SUBJECT: Hickory Lane Construction Ltd  
Development Permit / 42704 Prairie  
Avenue DATE: March 27, 2023

DEPARTMENT: Planning  
DP001674 PREPARED BY: Stella Xiao / sw

## STAFF REPORT ON DEVELOPMENT PERMIT DP001674

**DEVELOPMENT PERMIT NO. DP001674, 2023**

## Site Plan

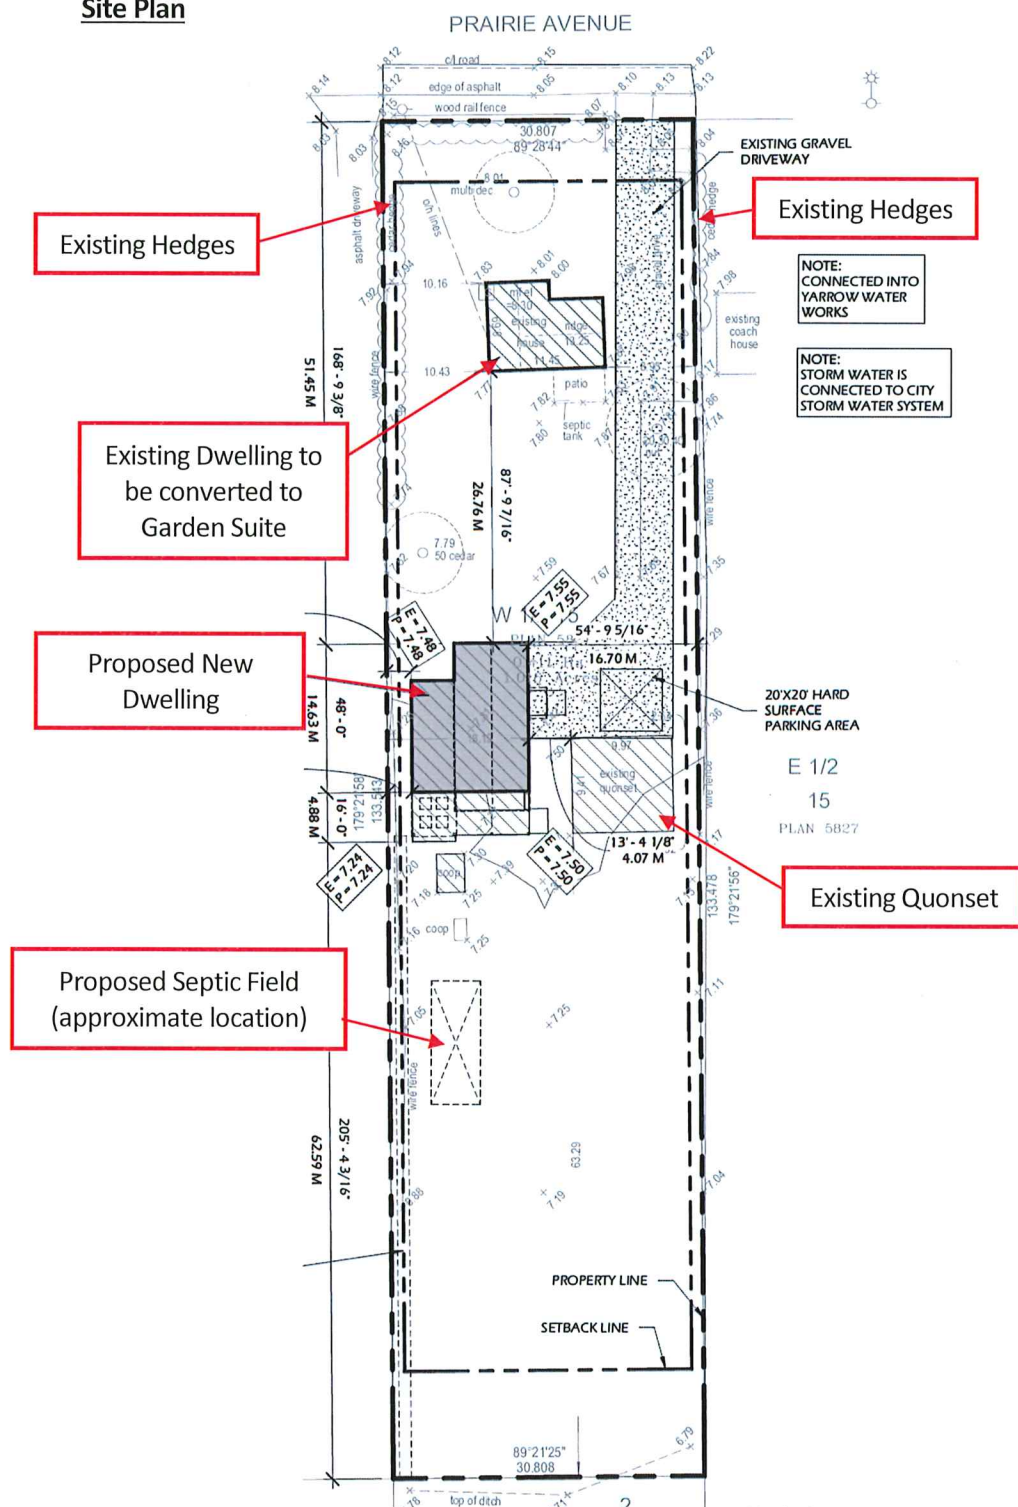
The proposed garden suite diverges from the DPA 10 design guideline that requires the detached ADU to be located behind or beside the principal dwelling, since the existing dwelling, proposed to be converted, is located within the front portion of the lot and will be in front of the proposed single detached dwelling. The departure is considered supportable in this instance as the garden suite is well-screened from neighbouring properties on the east and west sides with existing vegetation. Furthermore, with an overall property size of 0.4 ha and lot depth of approximately 133m (both significantly larger than the typical lot size and depth for an R1-A zoned property) and a proposed setback of approximately 51m for the new single detached dwelling, the privacy of the neighbouring properties and neighbourhood character is not expected to be impacted by the proposed development.

1.15	Single garage doors or double garage doors with windows or other architectural elements are used	N/A	None existing.
<b>2.0 Siting</b>			
2.1	Coach house or garden suite is located behind or beside the principal dwelling	No	A new principal dwelling is proposed at the rear of the existing dwelling to be converted into a garden suite.

- ☐ Development shall be in accordance with the approved site plan and elevations attached with Schedule "A";
- ☐ That the colours and materials used for the exteriors of the garden suite match those of the single detached dwelling;

Existing Dwelling (to be converted to Garden Suite)

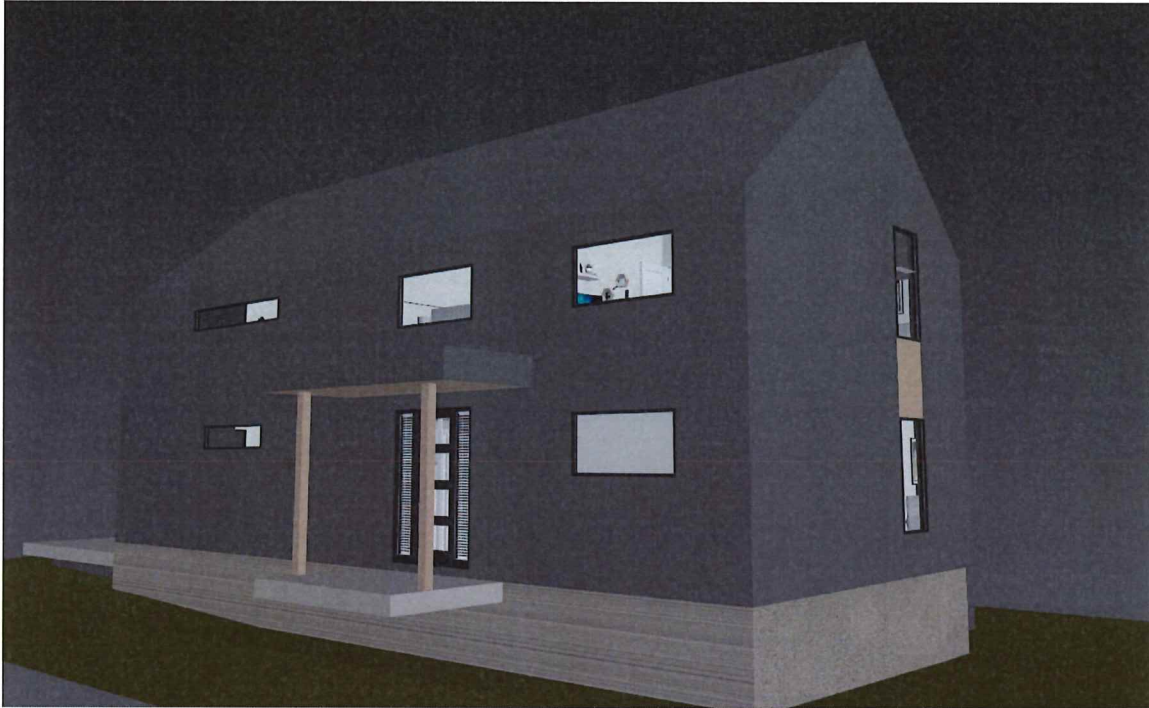
1.9	Oriented to the internal lot, laneway or flanking street	Partial	The front entryway is oriented towards the east; however, the driveway, garden suite design, and existing screening mitigates the impact of the entryway orientation on the neighbouring property.

1.10	Windows facing garden and side yards modestly sized	Yes	The garden suite windows are all modestly sized.
1.11	Use of frosting and/or clerestory windows on walls facing neighbouring properties	No	Most garden suite windows are at ground level. A condition has been added to the Development Permit to address the frosting of all windows above the height of existing screening.

- ☐ That all garden suite windows above the height of the existing screening be frosted; and,
- ☐ That all off-street parking areas are surfaced with an asphalt, concrete, concrete or brick pavers, or similar surface that is durable and dust free; and,
